Checklist for P.E. Annual Inspection for CCR Surface Impoundments, § 257.83(b)

Sikeston BMU Sikeston Power Station Bottom Ash Surface Impoundment

Annual Inspection

Bottom Ash Pond Annual Inspection Check Sheet

FIGURE 1 2022 ANNUAL INSPECTION BOTTOM ASH POND

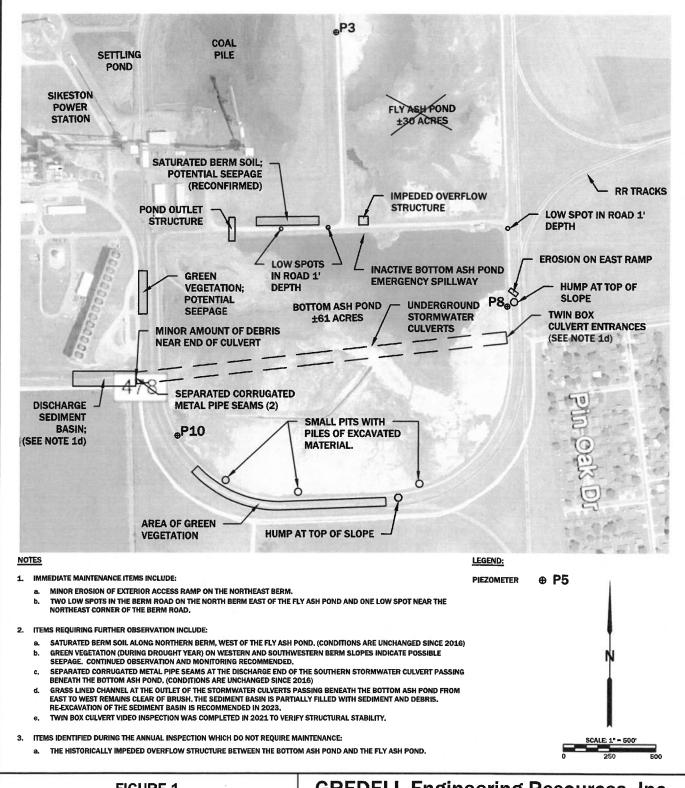
- b. IM conditions were observed during the 2022 site visit for three low spots in the berm road. Two spots are located on the north berm just west of the Fly Ash Pond, and a third spot at the northwest corner of the Bottom Ash Pond just south of the perimeter road intersection. Repair by adding gravel and grading to restore a minimum vertical alignment of ~ 322.0 is recommended along with continued monitoring.

Earth Embankment		
Item	Condition Code	Comments
Vertical & Horizontal Alignment of Crest	IM	Three low spots less than 1 foot in depth were observed in the roadway surface on top of the berm during the 2022 site visit. Two spots are located on the north berm just west of the Fly Ash Pond, and a third spot at the northwest corner of the bottom ash pond just south of the perimeter road intersection. Repair by filling with gravel and grading to restore the minimum vertical elevation and berm alignment is recommended along with continued monitoring.
Seepage/Wetness / Ponding Areas	OB (Ponding)	Past inspections note ponding in the perimeter flat bottom ditch inside rail loop. This appears to be caused by the flat grade of the railroad bed and does not appear to be seepage. The ponding restricts mowing of the ditch during wet periods, but otherwise is not a concern. No ponding was observed in 2022 due to drought conditions.

OB (Northern Berm Seepage)	An area along the northern berm of the Bottom Ash Pond, west of the Fly Ash Pond was identified as an area of potential seepage from the Bottom Ash Pond during prior inspections. No visual observation of erosion of the outer berm soils were observed in 2016 through 2022. 2022 observation indicates the area continues to be maintained. In mid-2018, Gredell Engineering subcontracted to Reitz & Jens, Inc. (St. Louis) to complete an evaluation of the area of the northern embankment of the Bottom Ash Pond. The report stated that the possible seepage did not have a negative impact on the stability of the embankments. Therefore, it is recommended that this area continue to be visually monitored to note any change in conditions. Future remediation of the wet area may be appropriate at a future date based on regulatory or other considerations.
	OB (Southwest Berm Seepage)	A saturated area along the southwestern berm of the Bottom Ash Pond was observed during the 2021 annual inspection. The surficial soil in this area was identified to be soft and appeared wet in this area. Green vegetation was observed at this location in 2022 during an annual drought condition, but no visual signs of erosion of the outer berm soils were observed in 2022 or during prior inspections. The area was able to be routinely maintained (i.e., mowed) and there was no evidence of rutting or other distress from mowing equipment observed in the area. Therefore, it is recommended that this area continue to be visually monitored to note any change in conditions. Future investigation of the wet area may be appropriate at a future date based on regulatory or other considerations.

Erosion/Rutting	IM	No evidence of erosion or rutting on the outside slopes of the berms were observed in 2022. However, three weekly inspection reports noted minor erosion of the East ramp, and erosion damage was observed during the site visit. The gravel berm roads were in good condition during the site inspection with the exception of the three low spots affecting the vertical alignment of the berm. While these minor erosion damages do not have the same significance as rutting and erosion on the outside slopes of the berms, they should be corrected to maintain a consistent vertical height of the perimeter berms. SBMU staff periodically remediated the conditions noted by grading the road surfaces and adding gravel where necessary.
Fencing	NI	Fencing is not adjacent to the Bottom Ash Pond.
Vegetation	GC	Vegetation on exterior slopes is generally maintained at less than 6 inches, however this federal CCR rule criteria has been remanded and, therefore, is not currently applicable.
